N412NAS1

# TECHNICAL BULLETIN

SAFETY RECALL: Headliner Metal Plate Retention

MODEL:	MODEL YEAR:	VIN:
New Range Rover Evoque (LZ)	2020	000181-025797

E257752

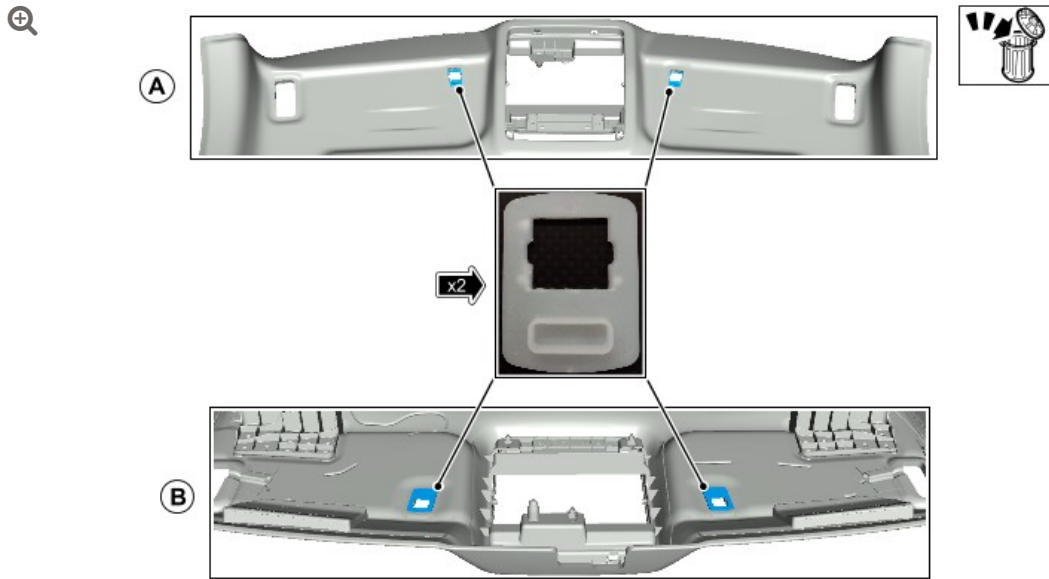
The headliner must be lowered for access; the 2 spacers shown must be removed and discarded.

- **A:** spacer location shown from beneath the headliner.
- **B:** spacer location from above the headliner.

E256358

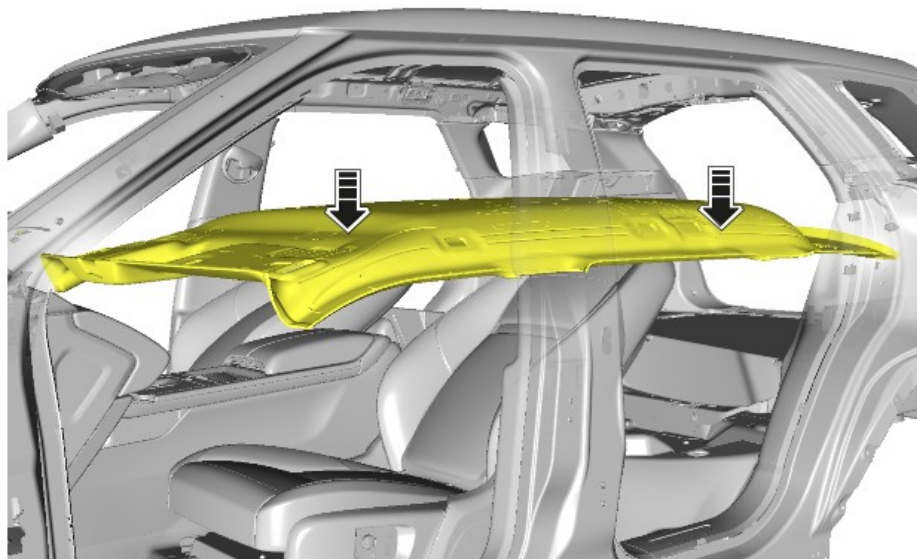
- **Do NOT remove the headliner from the vehicle.**
- The headliner must remain supported at all times. Take extra care to not damage the headliner.

Vehicle with roof opening panel shown; vehicles with fixed roof similar.

Lower the headliner for access (see TOPIx Workshop Manual section: 501-05 Removal and Installation - Headliner Lower For Access.) Do NOT attempt to remove the headliner from the vehicle.
